# Bradley Heights Apartments

## A 236-Unit Apartment Development Puyallup, Washington

**SITE PLAN**

**Site Plan**  
**Building H**

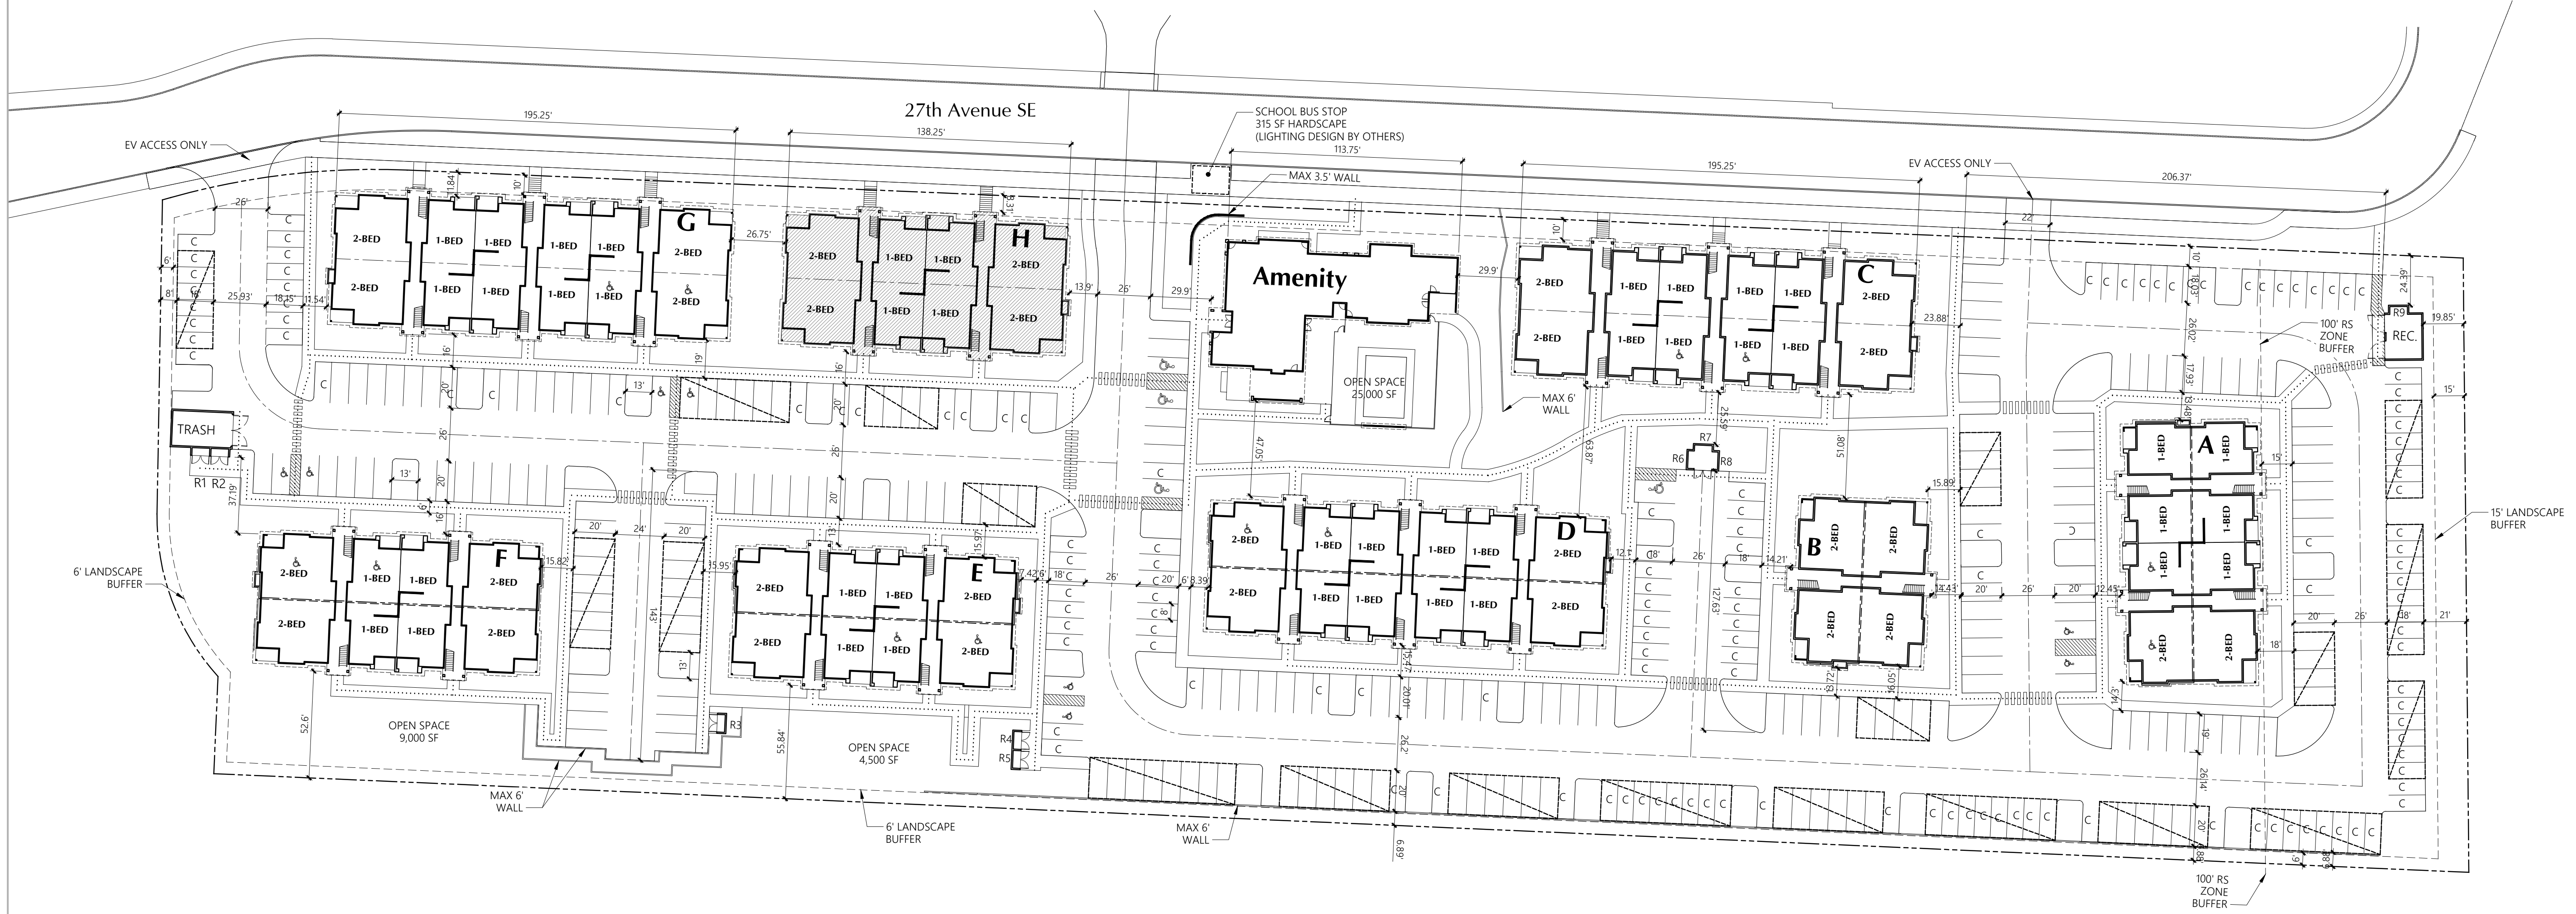
Provide egress plan with all dimensions with travel distance for all floors.

**BUILDING H** 2nd & 3rd LEVEL PLAN  
 1/8" = 1'-0" 3-STORY, 24-UNIT BUILDING

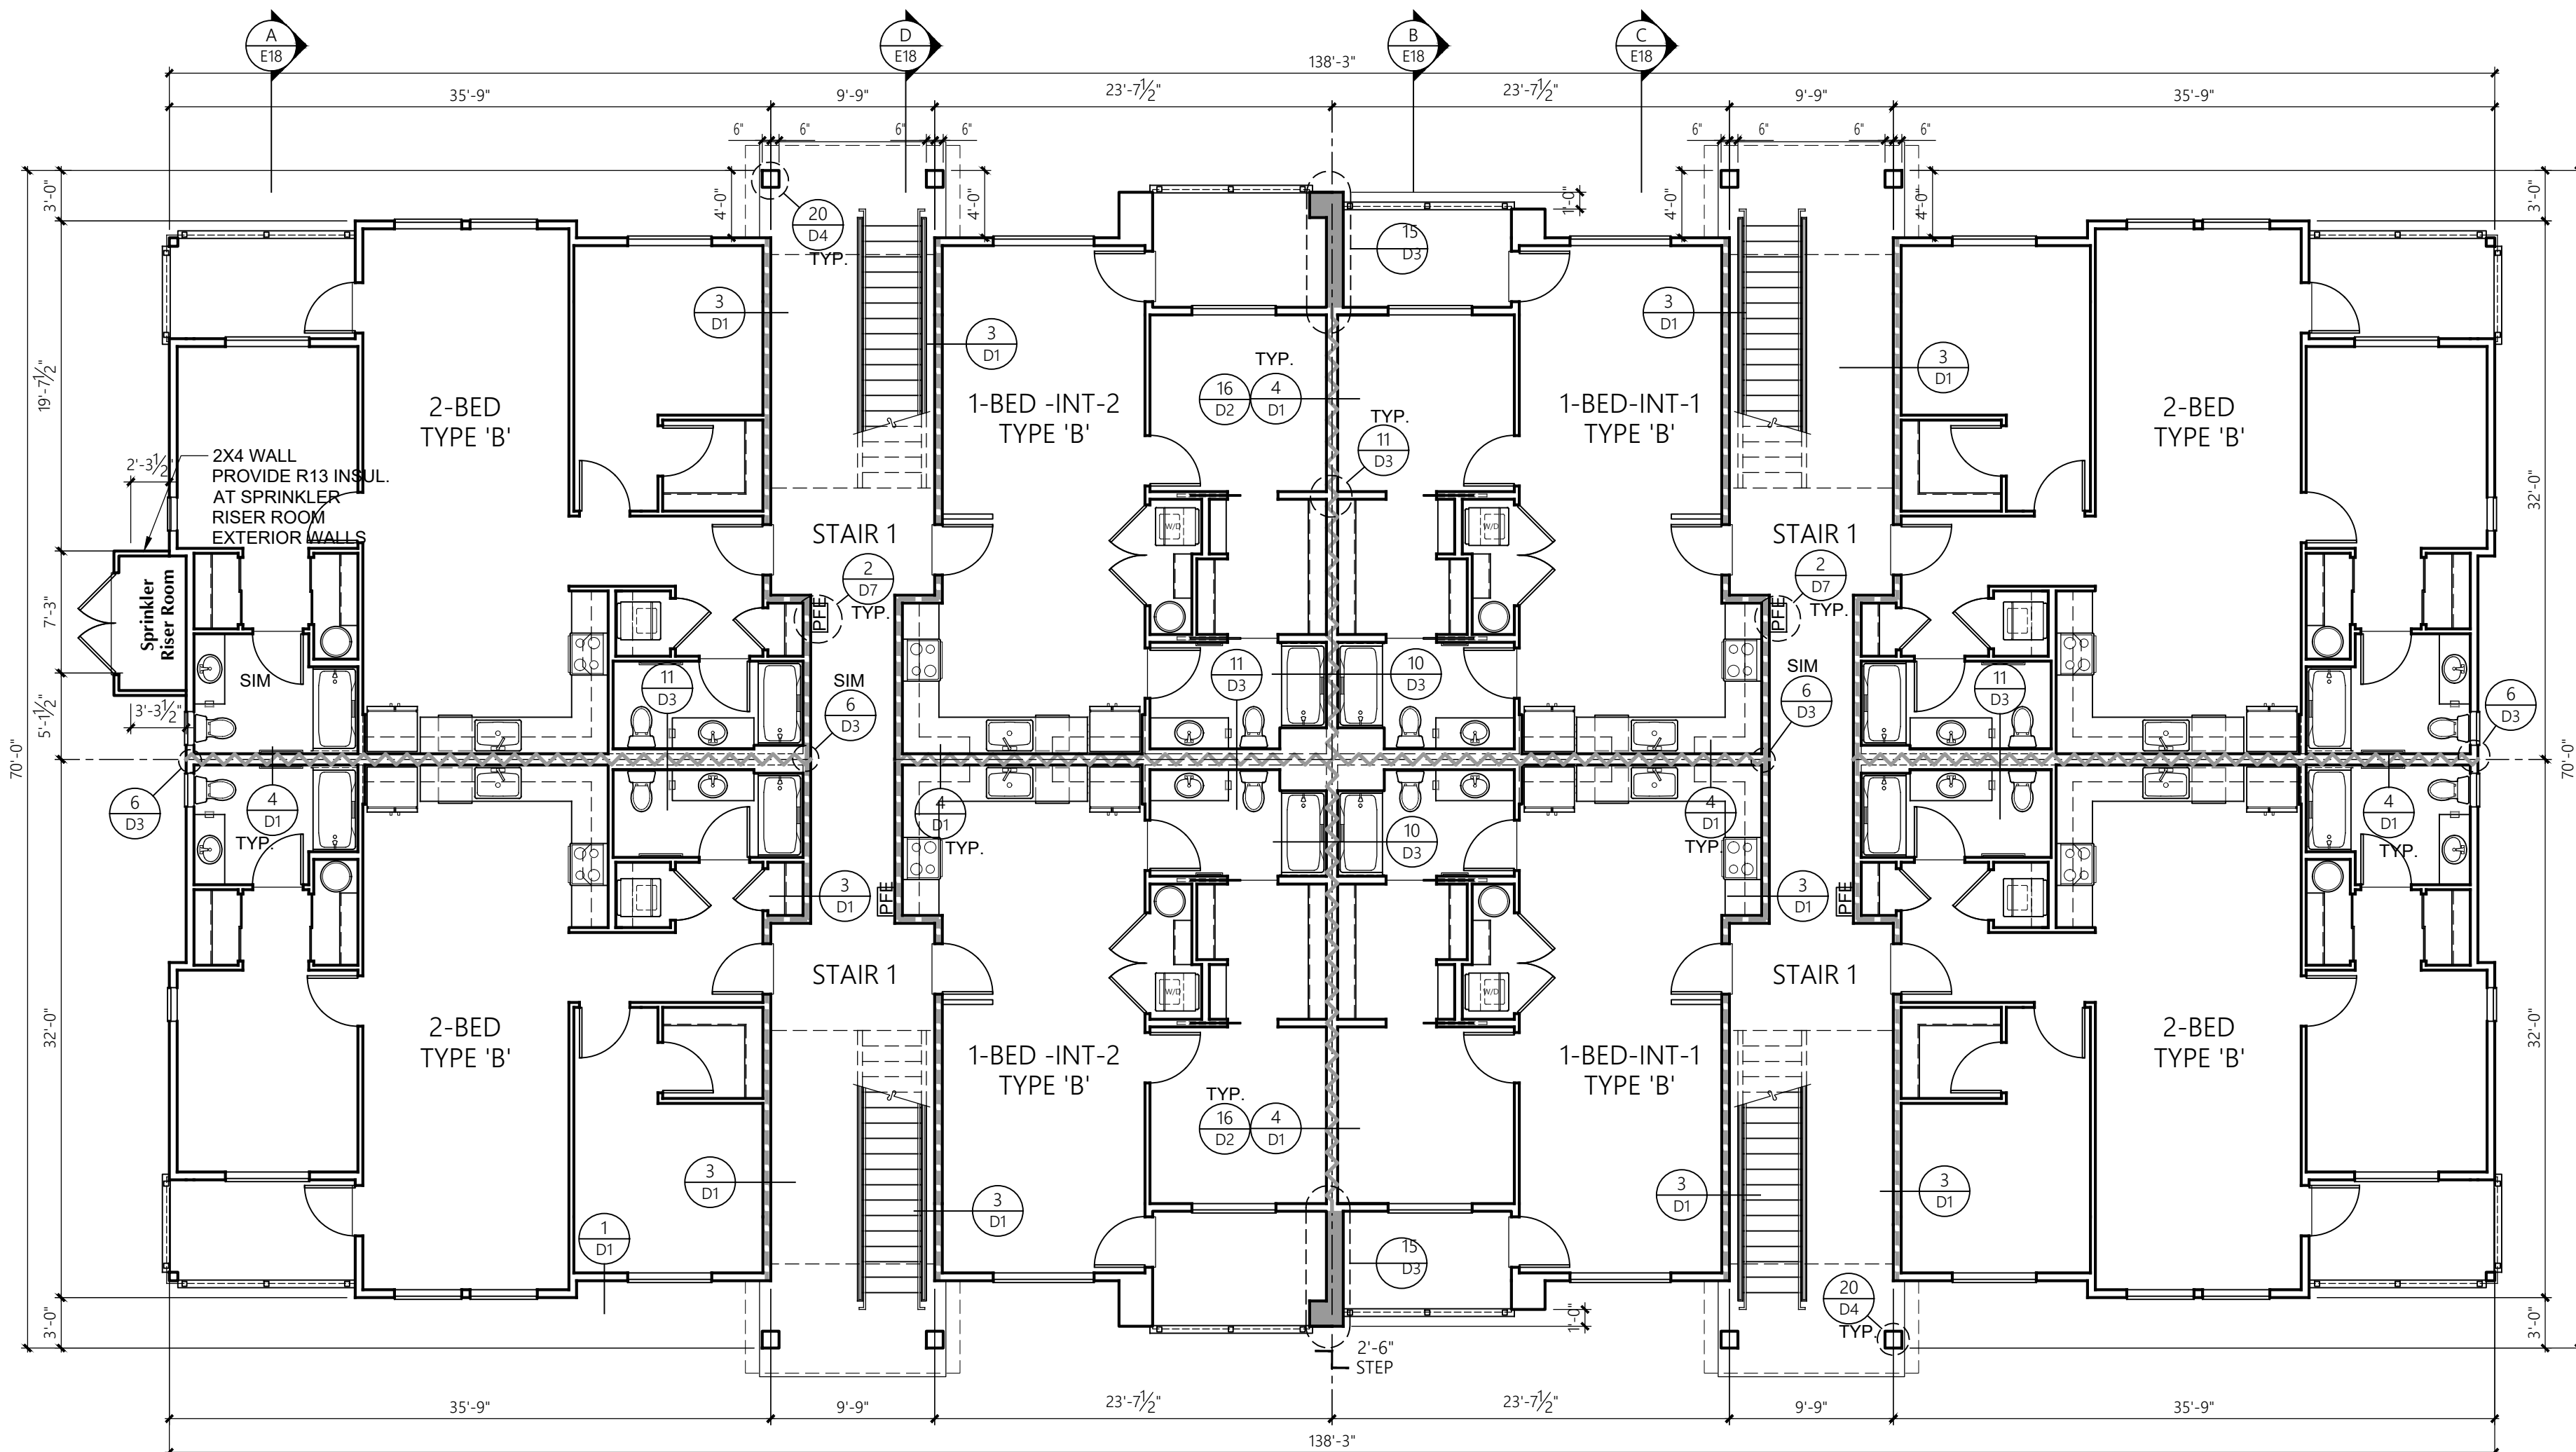
Provide fire stop detail for plumbing in 1-HR rated wall for all penetration in wall separating units. Wall section #6 unit separation wall does not reflect penetration in rated wall.  
 Page B12

BUILDING H 1st LEVEL PLAN  
 1/8" = 1'-0" 3-STORY, 24-UNIT BUILDING

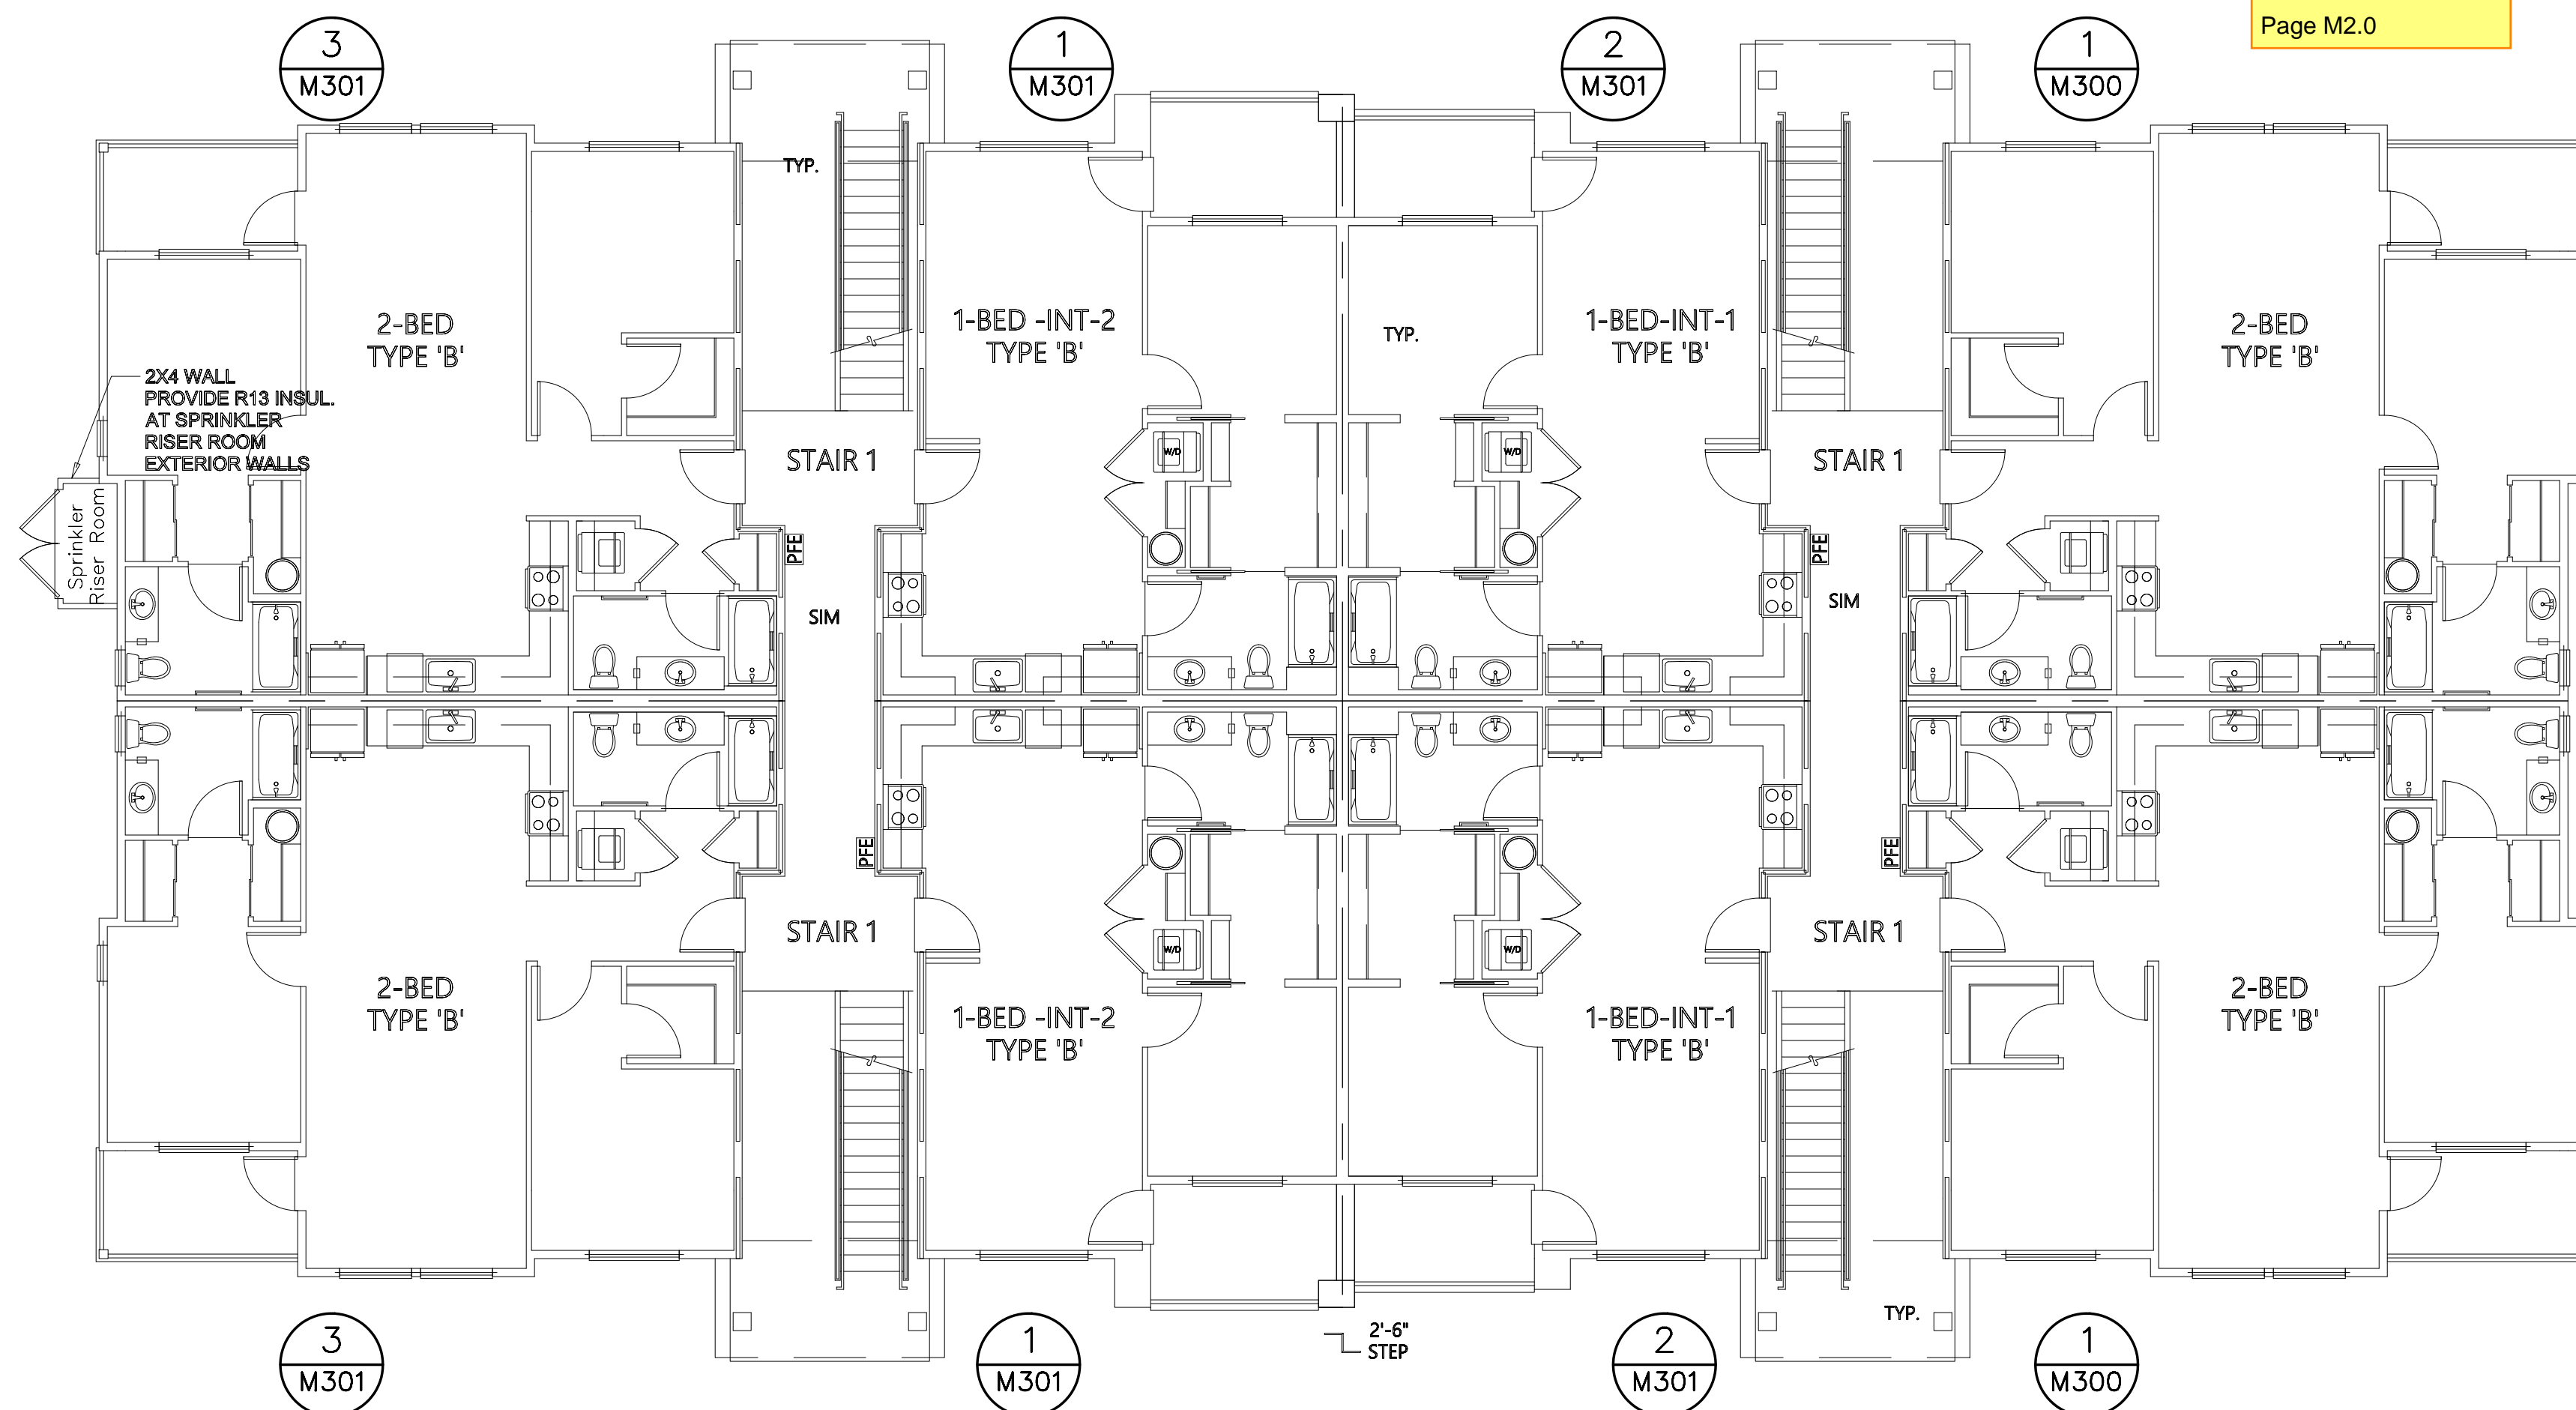
Provide lengths to all duct work for all floors to identify maximum duct length for all areas.  
 Page M2.0

Did not locate sheets M300-M303 duct sizes and length.  
 Page M2.0
